Staff Report

Infill Housing Design Review Committee

File Number: 8-B-21-IH

Location: 0 Oswald St. Parcel ID 69 N E 00402

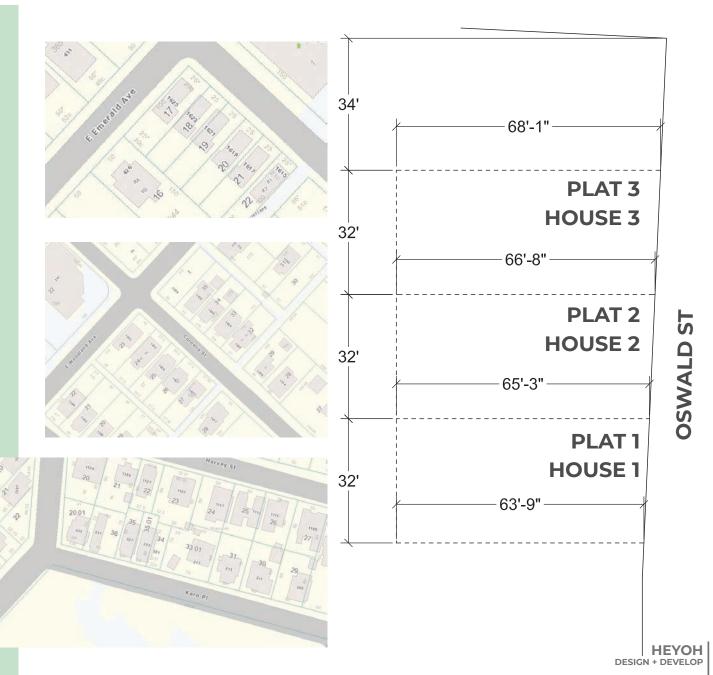
- 1. There is no minimum lot area or minimum lot width in the I-MU zoning district.
- 2. Guidelines note that the typical city lot prior to 1930 was 50' wide; which led to the development of houses which were relatively narrow and had substantial depth. While the three proposed lots are more narrow than recommended, many lots measuring 25'-35' in width exist in Oakwood-Lincoln Park and Old North Knoxville. The proposed lot size will lead to the development of house forms which reflect the guidelines (narrow facades with depth extending to the rear of the property).

- 3. The proposed three lots will be complimented by one similarly-sized new parcel to the north, and approximately four more to the south. The lots will create a new streetscape pattern fronting Oswald Street which will generally be compatible with Lincoln Park's overall character.

- 4. The provided lot dimensions are sufficient for the Design Review Board to review the "request for subdivision approval" (16.6.D) for the three new lots to be created. If there are any substantial deviations from the proposed lot size and layout on the final plats, final plats will require further review by the DRB.

HOUSE 2 FRONT ELEVATION

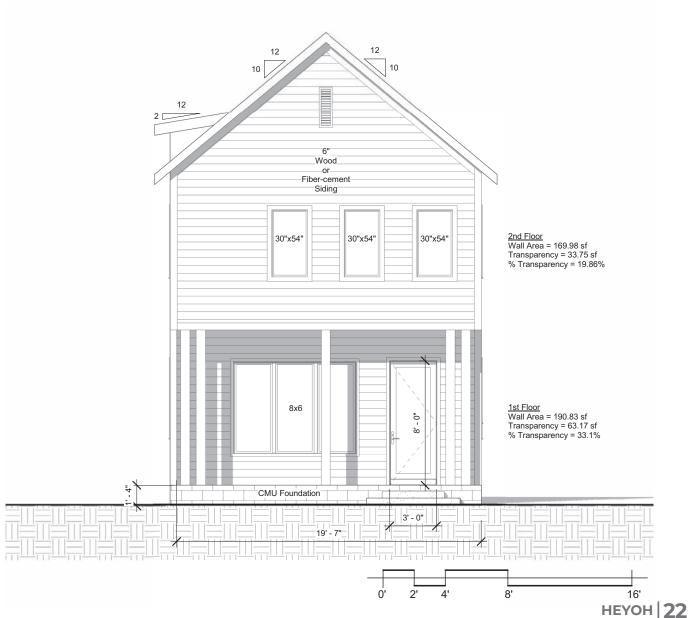
HOUSE 2

1. The house is proposed to be set 1' from the left (south) side property line. A deed restriction will be required to ensure adequate fire separation with the adjacent house while also allowing the proposed windows on the left side elevation.

- 2. The proposed 8' deep porch, recessed under the house's second story, does have historic precedent and will be a positive variation on the other two houses. The paired square columns contribute to the overall design.
- 3. Guidelines recommend a consistent ratio of solid (wall) to void (window and door openings), including on side elevations. Both side elevations feature a sufficient amount of transparency with generally consistent window placements and proportions.

HOUSE 3 FRONT ELEVATION

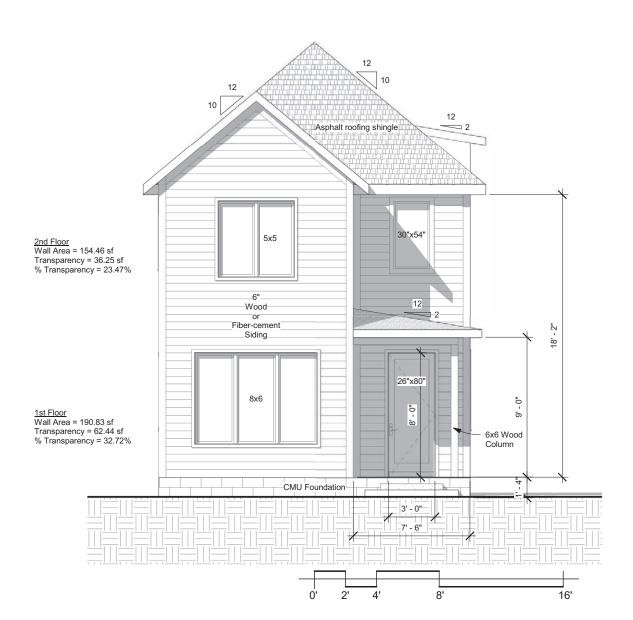
HOUSE 3

- 1. The house is proposed to be set 1' from the left (south) side property line. A deed restriction will be required to ensure adequate fire separation with the adjacent house while also allowing the proposed windows on the left side elevation.
- 2. The hipped-roof corner porch draws historic influence from similar two-story Queen Anne houses and will sufficiently vary from the other proposed houses.
- 3. Guidelines recommend a consistent ratio of solid (wall) to void (window and door openings), including on side elevations. The left (south) elevation features a large swath of siding with no transparency, but does include transparency on the side of the house that will be most visible from the street.
